HISTORIC LANDMARK COMMISSION PERMITS IN NATIONAL REGISTER HISTORIC DISTRICTS MAY 19, 2014 NRD-2014-0043 217 Congress Avenue Congress Avenue

Remove the existing non-historic storefront and façade and construct a new storefront and a second-story addition to the rear of the building.

217-219 Congress Avenue

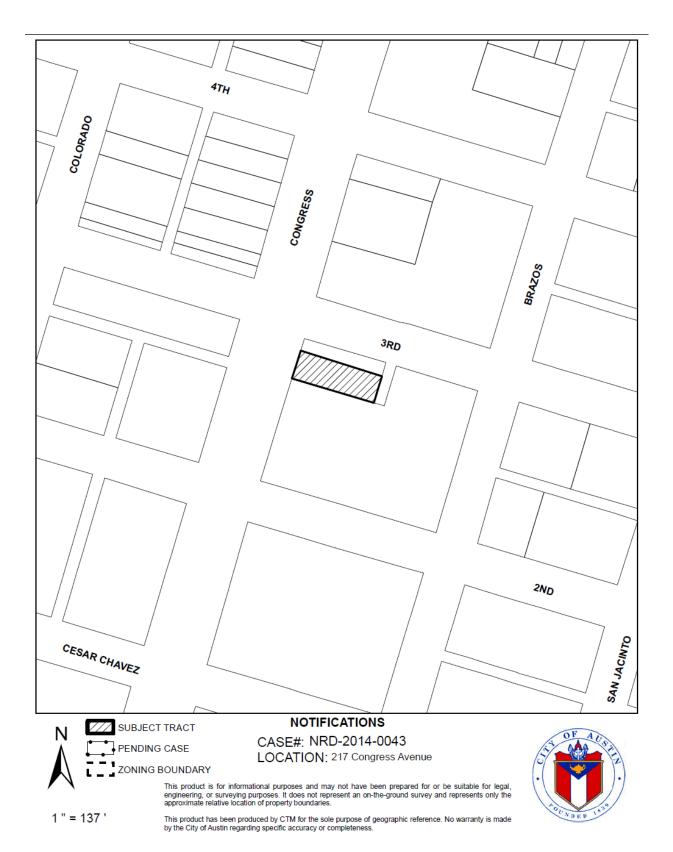
Approve as proposed with the recommendation that the applicant consider retaining the wood-framed windows in the second story of the building. The applicant's proposal is a very sympathetic re-working on the facades of these two buildings, which by virtue of their modifications, would not be considered contributing to the Congress Avenue Historic District today. The applicant's proposal retains the sense of the rhythm of the building integral to maintaining the architectural character of the district.
